TECHNICAL BULLETIN

► Clevlok Load Pin Retention Issue

Effective May 2022

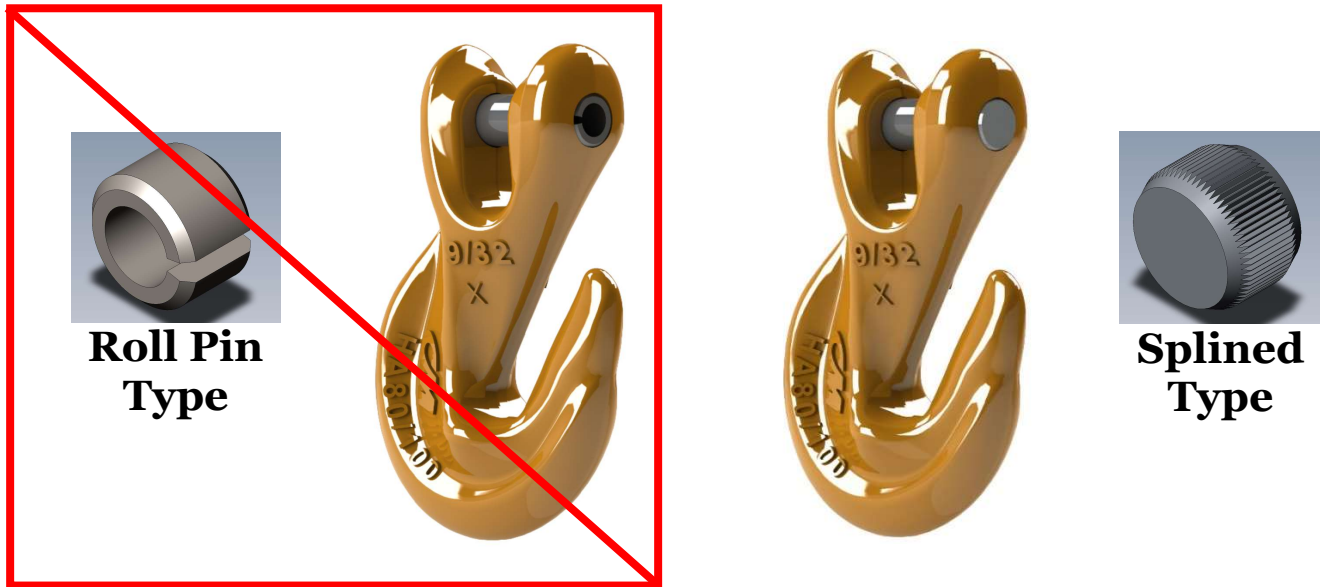
We have discovered a problem with the load pin retention on 9/32" G80 and G80/100 Clevlok products with roll pin type retaining plugs. Some of these sourced components are undersized. Load pins may fall out during normal operation.

- Immediately remove all 9/32" G80 and G80/100 Clevlok products with roll pin type retaining plugs (PN 495831) from service.
- Replace roll pin type retaining plugs (PN 495831) with CMCO supplied solid knurled type retaining plug (PN 495834).
